South Texas Project Electric Generating Station P.O. Box 289 Wadsworth, Texas 77483

December 28, 2010
U7-C-STP-NRC-100261

South Texas Project
Units 3 and 4
Docket Number PROJ0772
Response to Requests for Additional Information

Figure 36-1 Letter Designation of Main Steam Lines

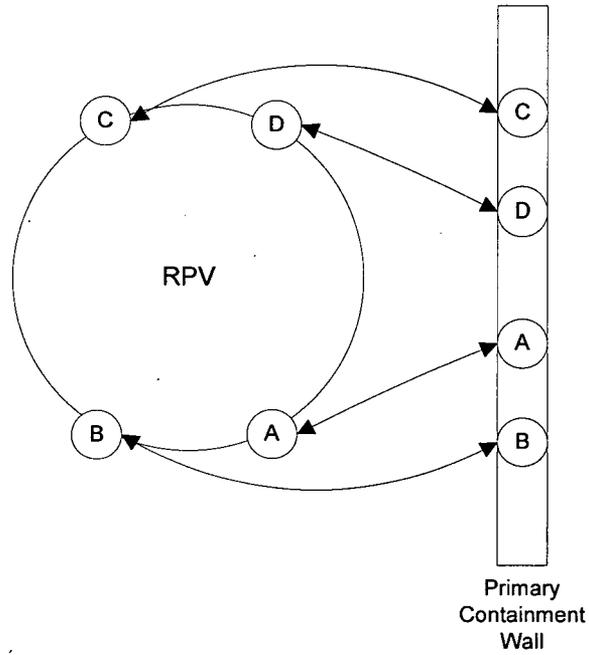
- a. What are the pipe lengths of the steam lines from the RPV to the primary containment wall and from the primary containment wall to the turbine stop/control valves?
- b. What is the approximate location of the pressure equalization lines?

- a. The pipe lengths of the steam lines from the Reactor Pressure Vessel (RPV) to the primary containment wall and from the primary containment wall to the turbine stop/control valves are shown in Table 36-1 below. The steam lines have been letter-designated as shown in Figure 36-1. The same designation applies in the turbine building for steam lines and stop valves.

- b. The pressure equalization lines are at the following three approximate locations: (1) at the bottom of the main steam line just before the inboard Main Steam Isolation Valve (MSIV), (2) downstream of the outboard MSIV prior to the drain line ascending to the main steam tunnel, and (3) between the equalizer header and the turbine stop/control valves. At the first location, the four main steam line equalizing lines connect to a common equalizing line prior to the inboard motor operated isolation valve (MO F011). The drain line has an outboard motor operated isolation valve (MO F012) in series with MO F011. At the second location, the four outboard drain lines connect to a common equalizing line via a third motor operator (MO F013). The equalizing lines also function to provide a drain line to the main condenser for low point condensate drains during plant operation.
